## **Monterey Subbasin Groundwater Sustainability Plan Development Comment Letters Received**

Figure 1

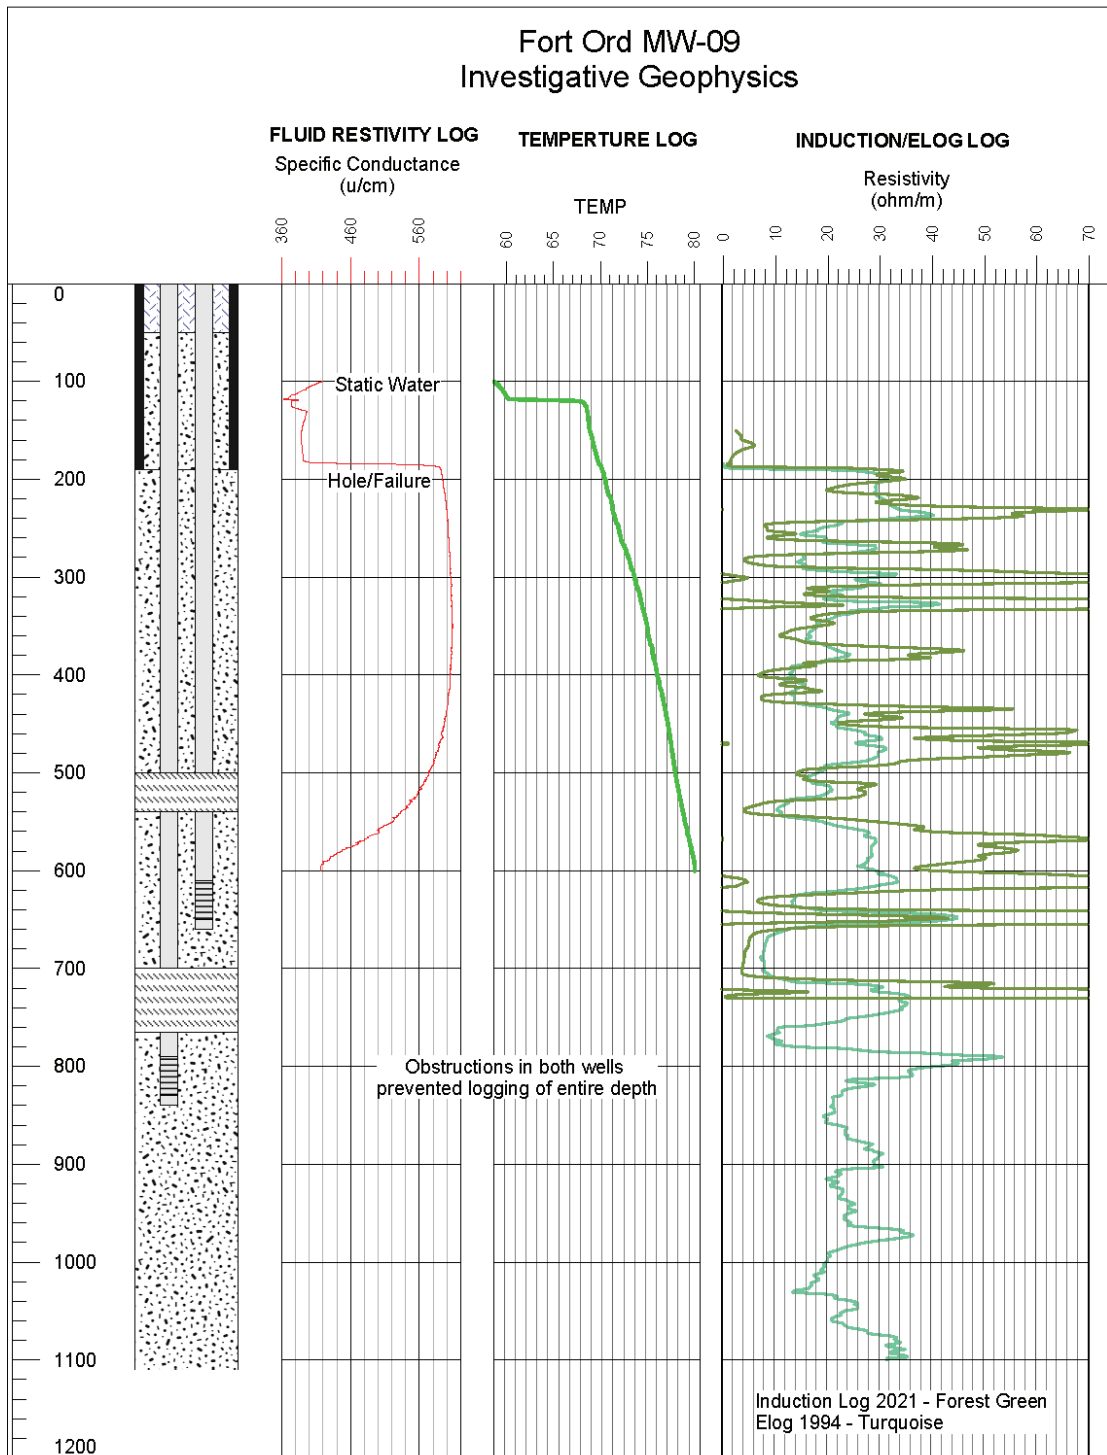
**CWC Figure 1: Arsenic in San Jerardo Well, Groundwater Elevation in Closest Monitoring Well**

Figure 2

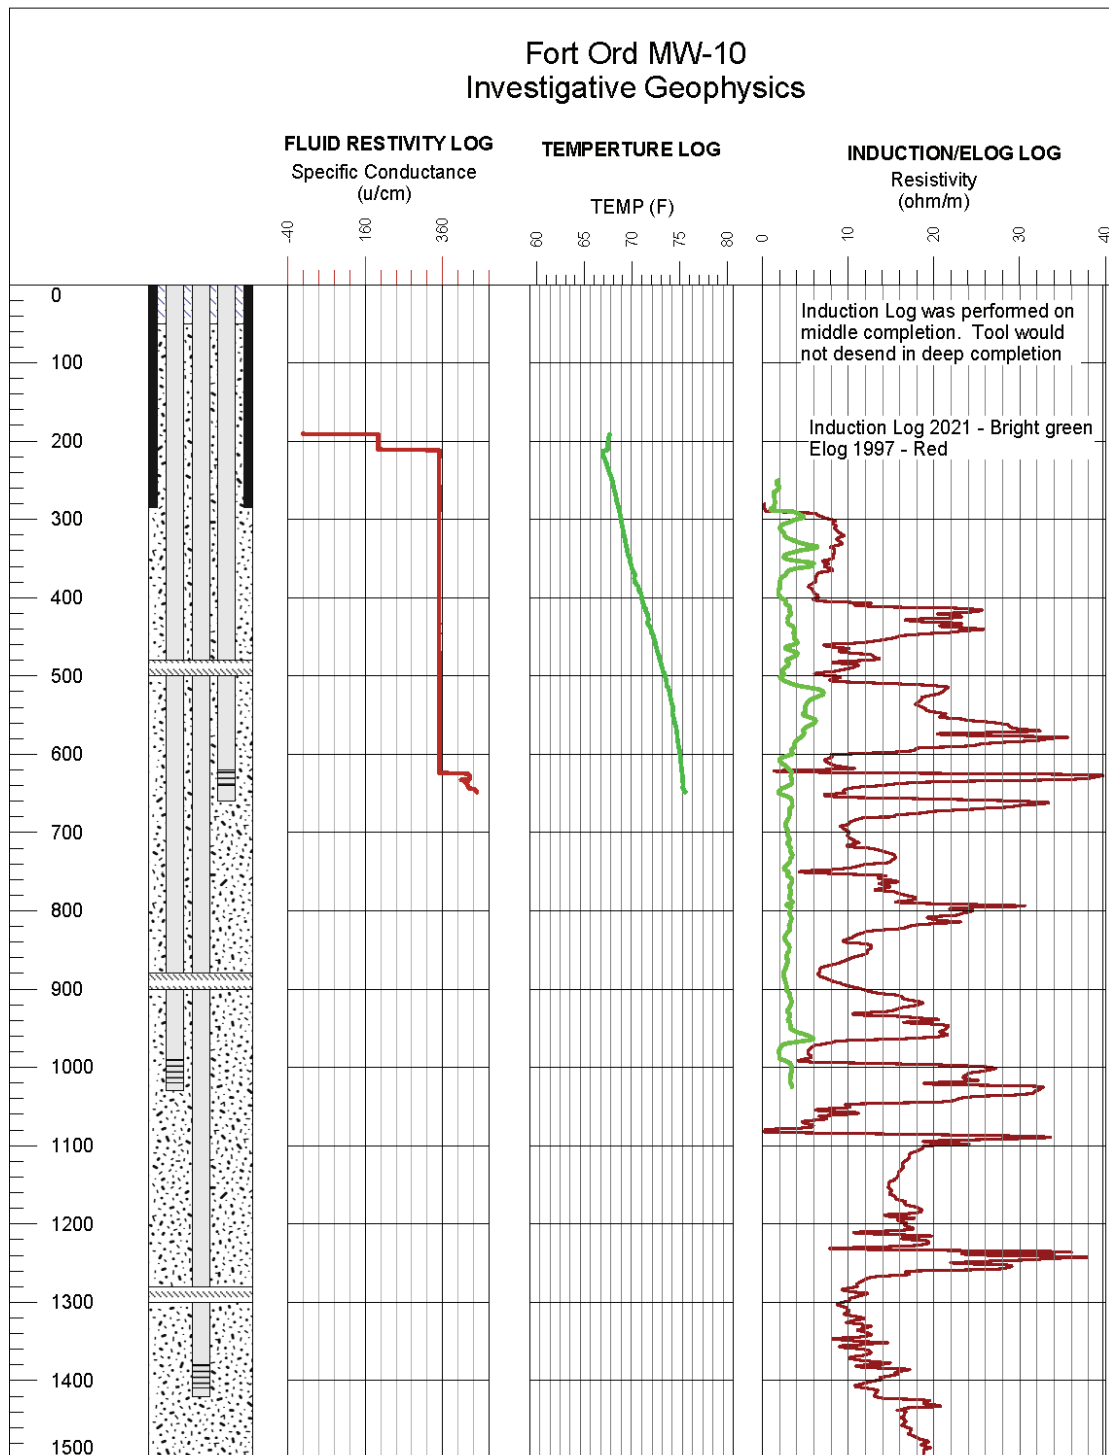
**CWC Figure 2: Nitrate in San Jerardo Well.**

CWC Figure 10 Screenshot of DWR Well Completion Report Map application in the area near San Jerardo Cooperative highlighting that several 1 mi. by 1 mi. square sections include private domestic wells less than 250 feet deep.

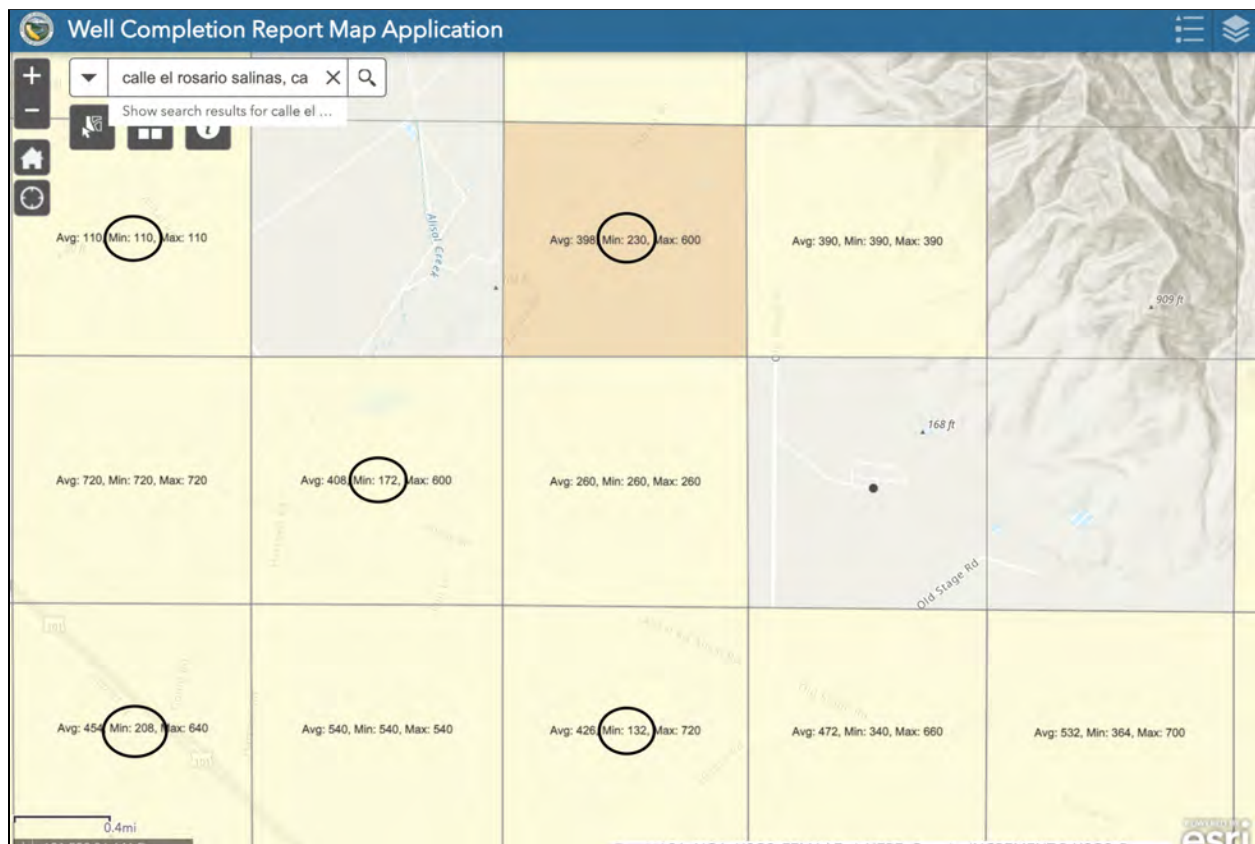
- The draft East Side Subbasin GSP Table 7-1 of Eastside Aquifer Groundwater Elevation Representative Monitoring Site Network shows all irrigation and observation wells (and no domestic wells) which range in depth from 299 to 1122 feet.<sup>24</sup> Yet, the DWR Well Completion Report Map Application<sup>25</sup> shows that 1 mile by 1 mile square sections near San Jerardo Cooperative include private domestic wells with the following minimum depths 110 ft, 210 ft, 172 ft, 208 ft, and 132 ft which are more shallow than all the wells in the current monitoring network (See CWC Figure 10).

CWC Figure 10: Screenshot of DWR Well Completion Report Map application in the area near San Jerardo Cooperative highlighting that several 1 mi. by 1 mi. square sections include private domestic wells less than 250 feet deep.

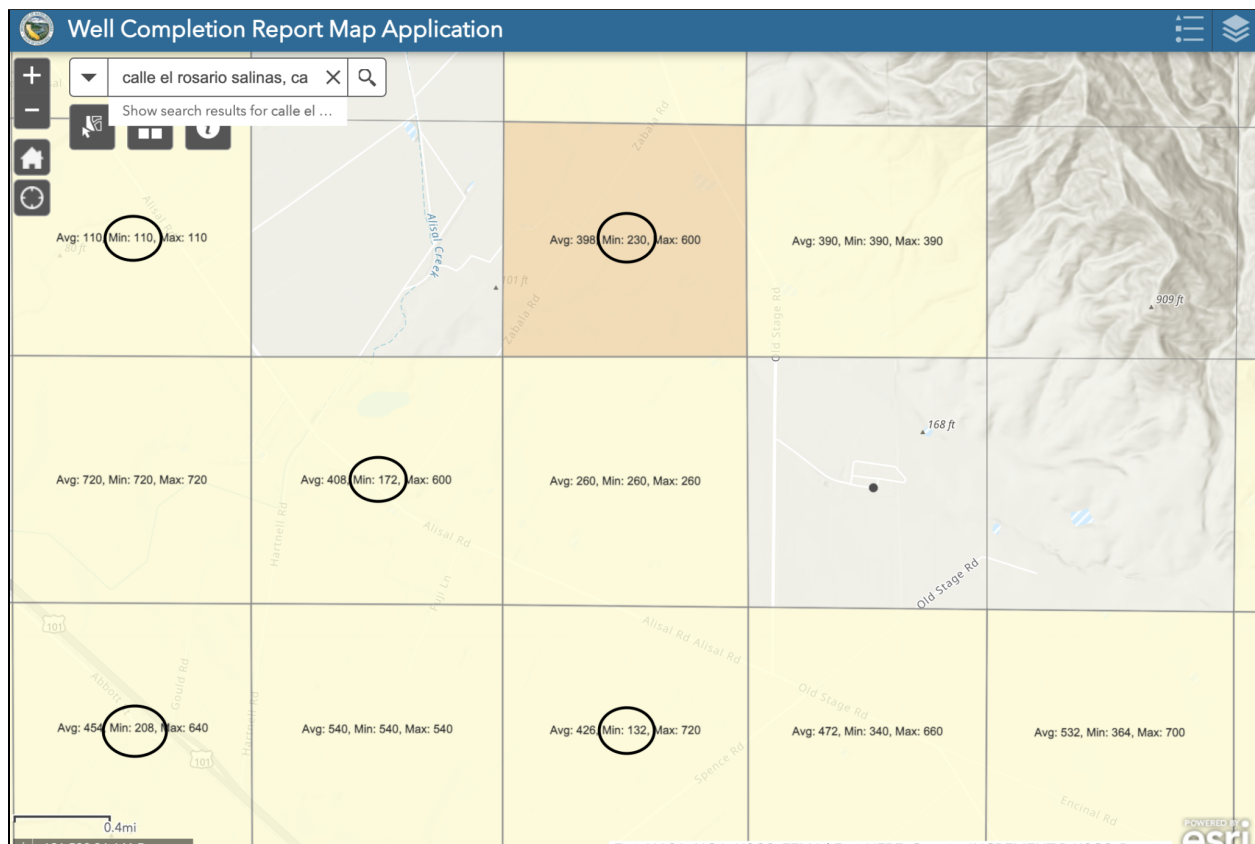
- The draft East Side Subbasin GSP Table 7-1 of “Eastside Aquifer Groundwater Elevation Representative Monitoring Site Network” shows all irrigation and observation wells (and no domestic wells) which range in depth from 299 to 1122 feet.<sup>24</sup> Yet, the DWR Well Completion Report Map Application<sup>25</sup> shows that 1 mile by 1 mile square sections near San Jerardo Cooperative include private domestic wells with the following minimum depths: 110 ft, 210 ft, 172 ft, 208 ft, and 132 ft which are more shallow than all the wells in the current monitoring network (See CWC Figure 10).
